TECHNICAL MEMORANDUM

DATE: February 23, 2024

SUBJECT: *1D Model Simulation of Subsidence in Northwest MZ-1—Subsidence Management Alternative #1 (FINAL)*

APPENDIX A – RESPONSES TO GLMC COMMENTS24

Figure 13. Northwest MZ-1 Guidance Level versus Projected Heads and Modeled Compaction at PX under SMA-1

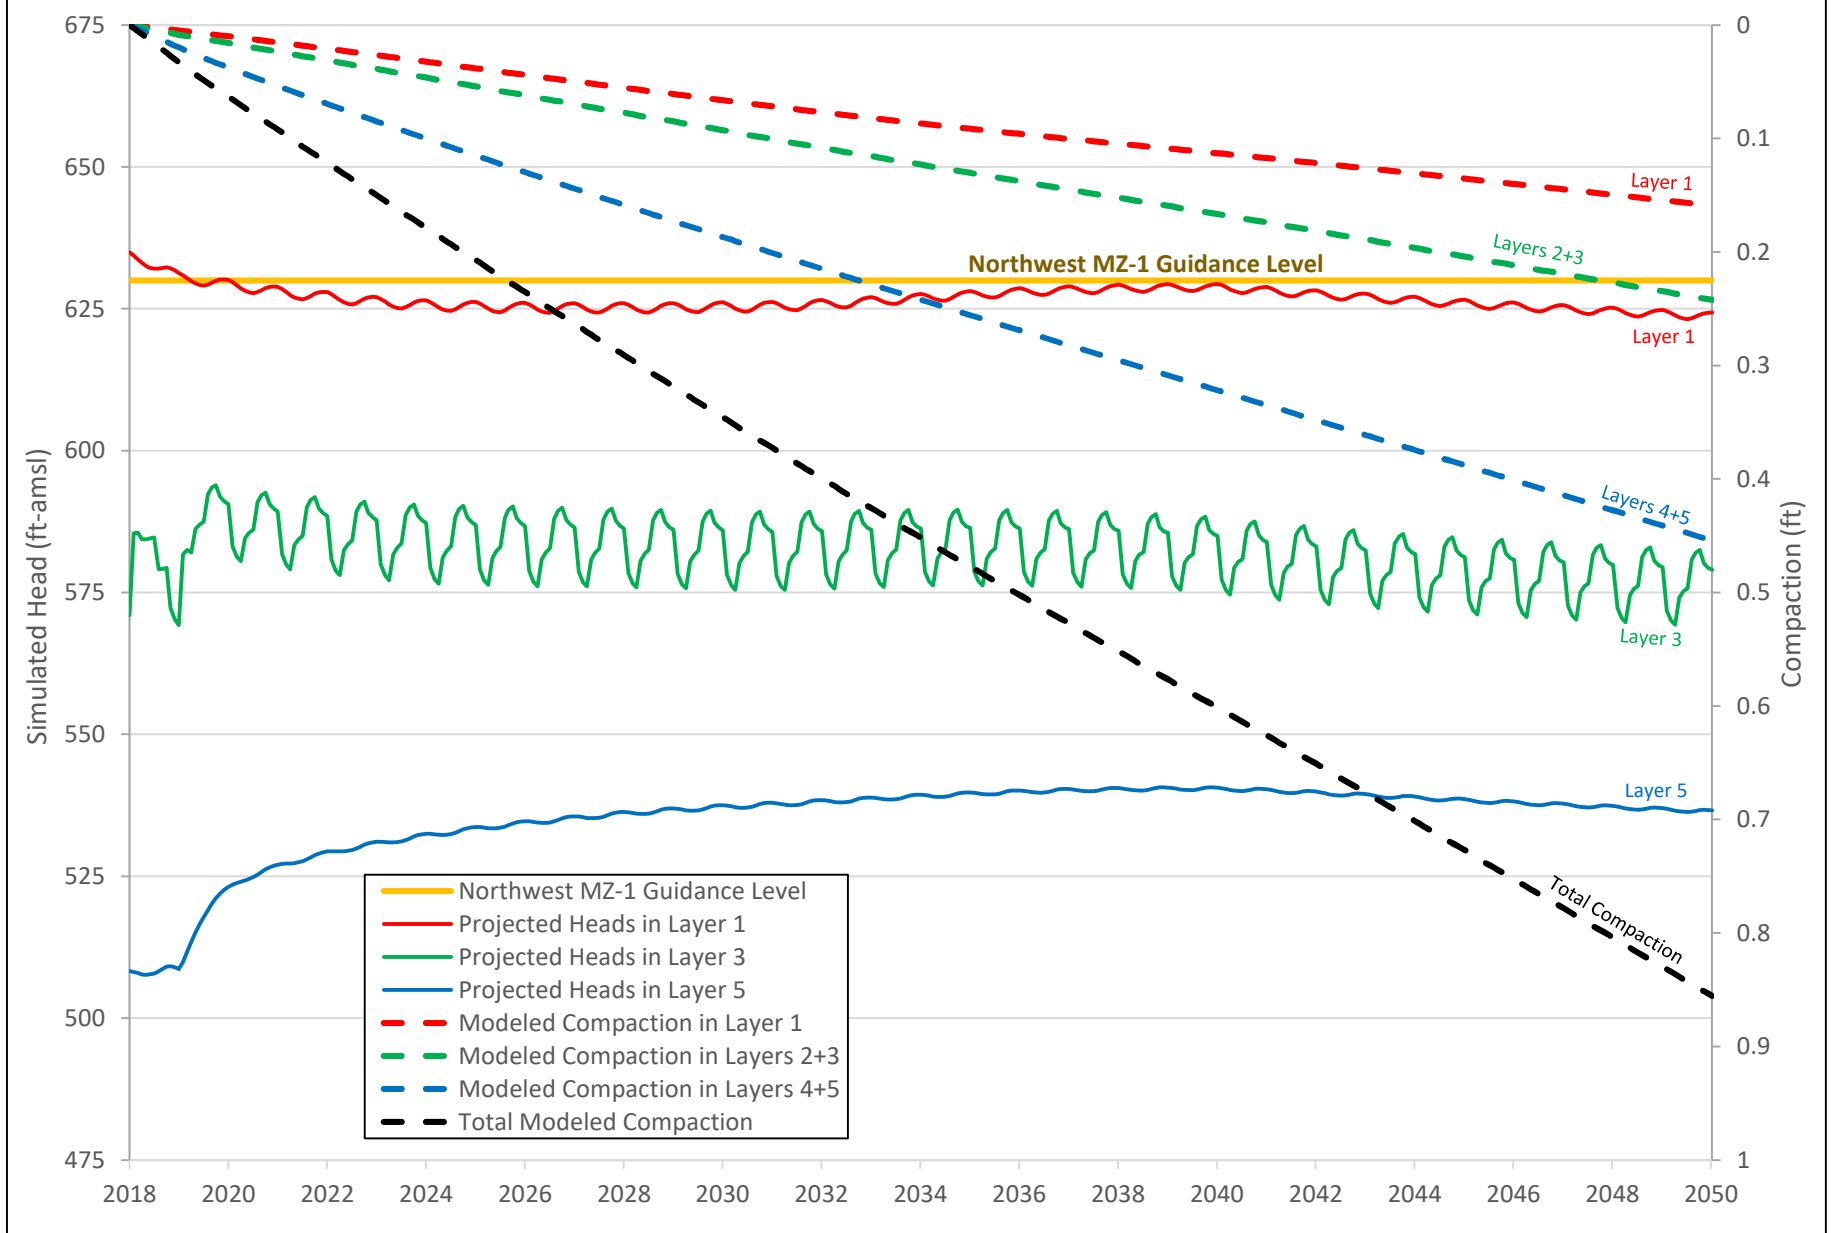
Comment 15 – Figures 13

We recommend removing this figure until additional analysis is conducted as discussed in comments regarding Conclusions and Recommendation?

This figure should remain to illustrate the “preliminary” Guidance Level.
